Addendum 2 / 03.16.2018 Large Equipment Bid Hamblen Co. School Nutrition

Hamblen County Large Equipment Bid 2018-2019

- The following shall replace the detailed specification for West End Elementary Item # 7 and Item # 8:

WEST ELEMENTARY SCHOOL

WEST SIDE (END) ELEMENTARY
COOLER

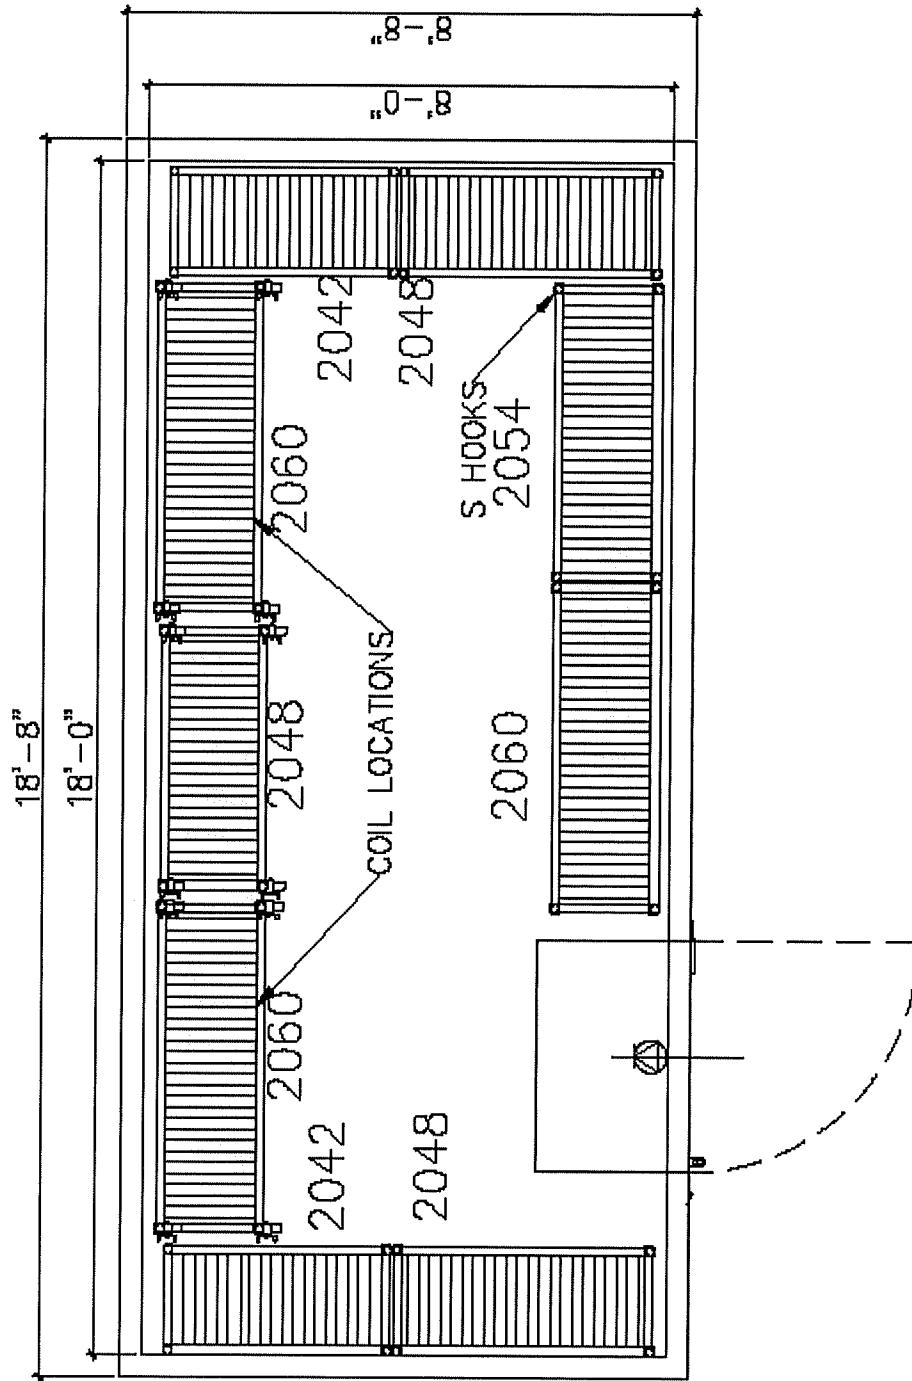
ITEM 7 WALK IN COOLER (1 REQ'D)

The Food Service Dealer/Contractor is responsible for disconnection and demolition and removal of the existing walk-in. They are responsible for disposal of these units. The new COOLER IS going in the location the existing cooler. When demolition is complete Hamblen County or an agent on their behalf will determine if any concrete work is required before the new cooler is installed.

Drains are existing in front of this unit for utilization on condensate line.

The compressor is to be located on the roof on a stand provided by the Food Service Contractor. The existing compressor is located there now so existing roof penetrations and disconnect (if correct volt/phase) can utilized for the new unit.

Hamblen County requires a stand to put the compressor on the roof of the building.

Dealer to provide AND VERIFY SIZING.

1ea 2" x 2" x 1/4" galvanized angle condensing unit racks – 1ea approx 30" x 38" x 30" tall. Each rack with notched and fully welded corners with welds painted with rust resistant paint. Each rack to have a 6" x 6" treated lumber runner to attach to the long side of each unit. 2ea runners per unit making the overall height of the racks to be 36".

THERMO-KOOL Walk-in Cooler

18' 8" x 8' 8" x 7' 6" High

Insulation: 4" DURATHANE, all-urethane foamed-in-place (Class 1)
